Planning Application No. A/YL-SK/374

Table A: Responses to Departmental Comments

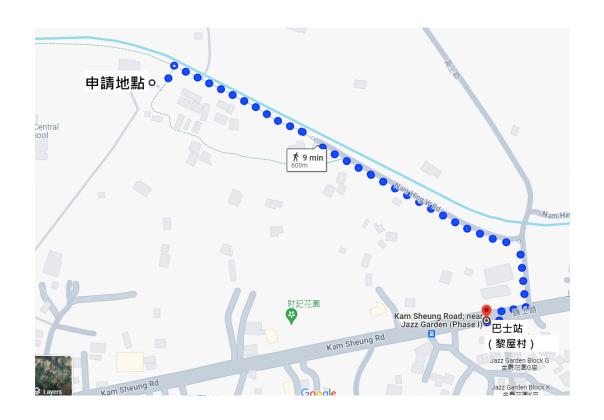
| | Departmental Comments | Responses |
|-----|---|--|
| (2) | The applicant should provide nearest public transport services and indicate on the layout plan; | 從錦上路巴士站(黎屋村)到申請地點,步 行距離約9分鐘,請看下圖。 |
